SECTION 96 SUBMISSION

DEE WHY RSL CLUB - 932 PITTWATER ROAD
STAGE 5 CLUB EXTENSION

THIS PLAN TO BE READ IN CONJUNCTION WITH
MOD2018/0119
NORTHERN BEACHES COUNCIL

PROJECT:
STAGE 5 - CLUB EXTENSION
PHASE 2 WORKS - SOUTHERN
CARPARK & ENCLOSURE

DRAWING TITLE:
CAR PARK LEVEL 2 EXISTING AND
DEMOLITION PLAN

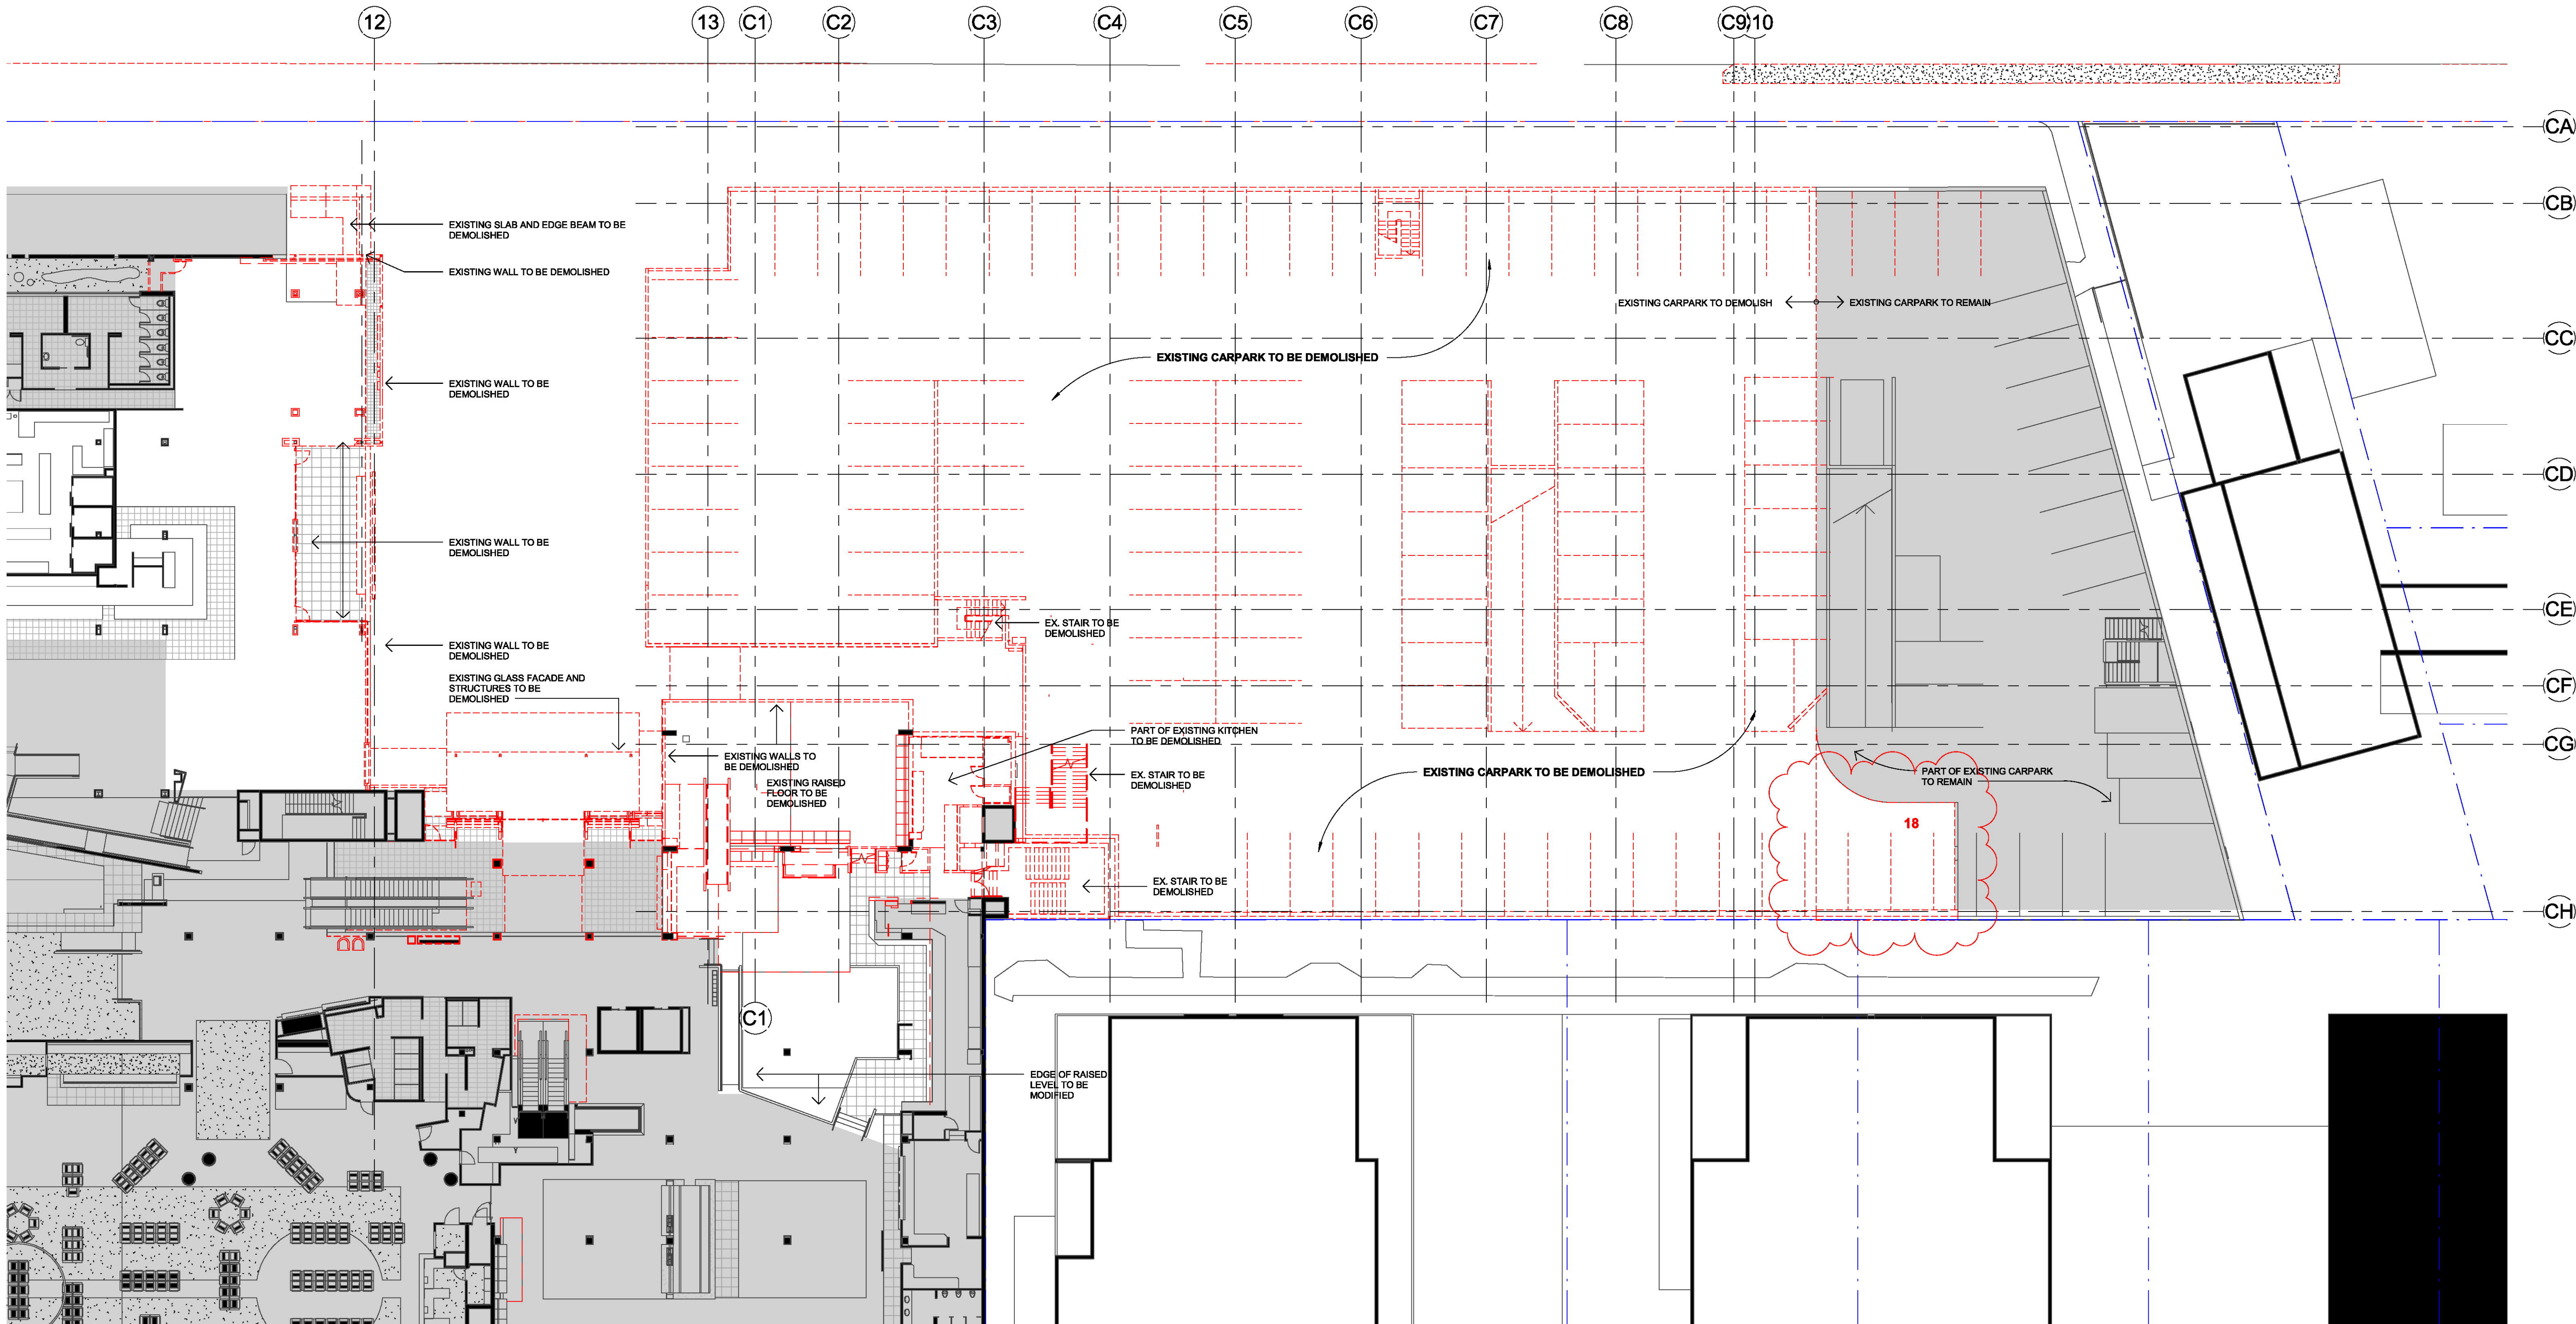
1. RELOCATED OPEN PLAN ROOM AT THE ROOF LEVEL
2. MODIFIED ROOF OPENING ABOVE MAIN ENTRANCE
3. MODIFIED CENTRAL SKYLIGHT (REDUCED HEIGHT, MODIFIED PITCH)
4. MODIFIED COURTYARD: TWO OPEN COURTYARDS AND ONE SKYLIGHT COVERED AREA INSTEAD OF ONE LARGE GLASS ROOF. REDUCED HEIGHT AND PITCH
5. MODIFIED SMOKING TERRACE: ROOF OPENING, SIZE AND PLANTED AREA. AREA REDUCED BY 21m²
6. REDUCED NUMBER OF ROOF SKYLIGHTS ABOVE ASIAN RESTAURANT: 2 INSTEAD OF 6 TO SUIT THE NEW INTERNAL LAYOUT
7. MODIFIED EXIT STAIR: POSITION, CONFIGURATION, METAL ROOF NO LONGER REQUIRED
8. CONCRETE ROOF INSTEAD OF METAL DECK ROOF FOR THE MAJORITY OF THE BUILDING EXTENSION
9. NO SLAB ABOVE THE EXPOSED CAR PARK LEVEL 2 IN THE SOUTH AREA
10. NEW ACOUSTIC METAL ROOF ABOVE REVISED LOADING DOCK

- facade
11. MODIFIED FACADE APPEARANCE DUE TO CHANGES IN THE CAR PARK LEVELS, LOADING DOCK AND EGRESS STAIRS
 12. REMOVED LOUVRES ON THE BACK FACADE (WESTERN FACADE) DUE TO MECHANICAL RISER NO LONGER REQUIRED / REVISED LOCATION FOR EGRESS DOORS
 13. 2m WIDE INTERNAL EGRESS STAIR MODIFIED INTO TWO 1m WIDE EXTERNAL STAIRS WITH DECORATIVE BALUSTRADES
 14. EXTENT OF LEVEL 2 (MAIN TRADING LEVEL) REDUCED BY 8328mm FROM THE SOUTHERN BOUNDARY AND INCREASED BY 1100mm TO THE EASTERN BOUNDARY
 15. MODIFIED FACADE CURTAIN WALL MULLION BLADES
 16. CONCRETE BLADE WALL REDUCED BY 1.47m IN HEIGHT AND 6.2m IN LENGTH
 17. VERTICAL FINIS REMOVED FROM BACK WALL (WESTERN FACADE)

- ground/landscape/floor plate
18. REVISED LOADING DOCK ENTRANCE AND LOCATION/ ENLARGED DEMOLISHED AREA IN THE EXISTING RETAINED SOUTHERN CAR PARK
 19. NEW / MODIFIED EGRESS PATHS FROM EXISTING CARPARK LEVEL -1. NEW CARPARK LEVEL 1.

20. RELOCATED ELECTRICAL SUBSTATION / LANDSCAPED AREA MOVED TO SUIT
 21. MEDIAN STRIP ADDED AT ENTRY TO PROVIDE PLACE OF REFUGE AND ENSURE WIDTH OF ENTRY/ EXIT IS LESS THAN 8m AS PER DA CONDITION 23

24. BASEMENT CAR PARK LEVEL -5 ADDED.
 25. CAR PARK ENTRY / EXIT MOVED TOWARD NORTH BY 3044mm
 26. PLANTER MODIFIED ON THE BACK (WESTERN) FACADE DUE TO REDUCTION OF THE MAIN TRADING FLOOR SLAB

27. LOCATION OF AIR INTAKE MODIFIED
 28. EXTENT OF RESTAURANT REDUCED BY 136m²
 29. CLUB ENTRANCE ACCESSIBLE RAMPS MODIFIED
 30. ONE ADDITIONAL EXISTING CAR PARK SPACE TO BE REMOVED FROM EXISTING NORTHERN CAR PARK

31. SOLID MASONRY WALL ADDED BETWEEN EXISTING ZONE D CAR PARK AND LOADING DOCK ACCESS.
